## 2016-2017 MX-5, 2016-2017 CX-3, and 2016-2017 CX-9 - Blind Spot Monitoring (BSM) System Change (Update)

The 2016-2017 MX-5, 2016-2017 CX-3 and 2016-2017 CX-9 BSM system vehicle detection has changed. Although the overall function is the same as previous vehicles, vehicle detection is different. Below is brief BSM comparison between the 2016-2017 MX-5/CX-3/CX-9 and other Mazda vehicles. For detailed BSM system information, refer to Service Highlights.

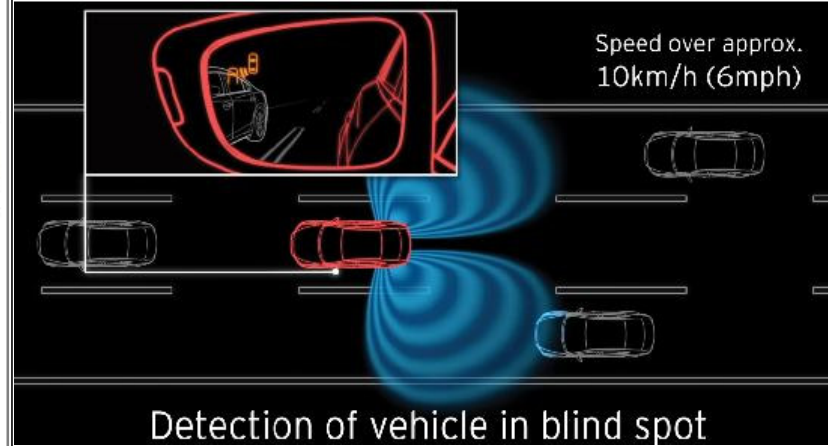
Other Mazda Vehicles Equipped With BSM	2016-2017 CX-3, 2016 MX-5 and 2016-2017 CX-9*
Detection area behind vehicle	7 m (23 ft)	<ul style="list-style-type: none"> <li>• 50 m (164 ft)</li> <li>• Within 5.5 seconds of vehicle approaching from rear</li> </ul>
Vehicle Detection		
BSM Indicator OFF

- No vehicle detected in the MONITORED AREA
- High speed difference with vehicle in the MONITORED AREA.

- No approaching vehicle in the ALERT AREA
- Vehicle in the ALERT AREA is cruising at a lower speed

- Vehicle detected in the MONITORED AREA
- Low or similar speed difference with vehicle in the MONITORED AREA.

- Detected approaching vehicle in the ALERT AREA
- Approaching vehicle reaching the rear of your vehicle within 5.5 seconds
- Vehicle in the ALERT AREA is cruising at same speed or higher

Special Service Tool  
(SST)

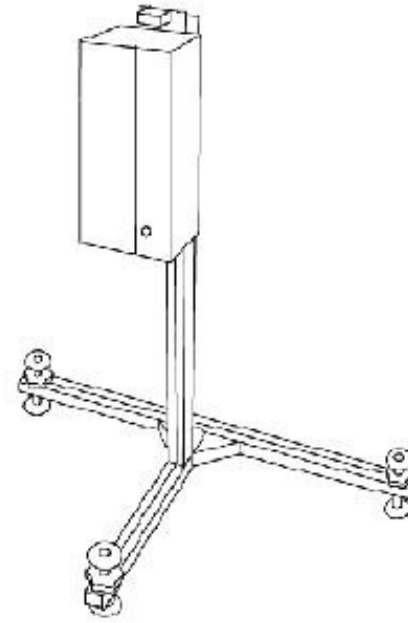
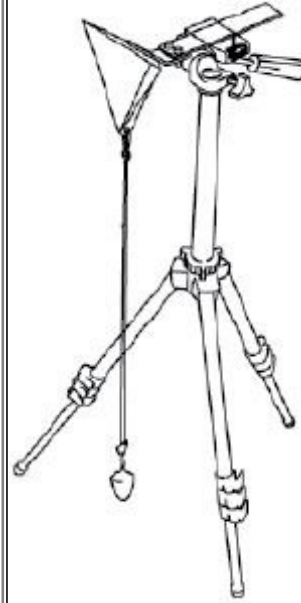
Reflector (\*Including 2016-2017 CX-9)

Doppler Simulator (2016-2017 MX-5 and 2016-2017 CX-3 only)
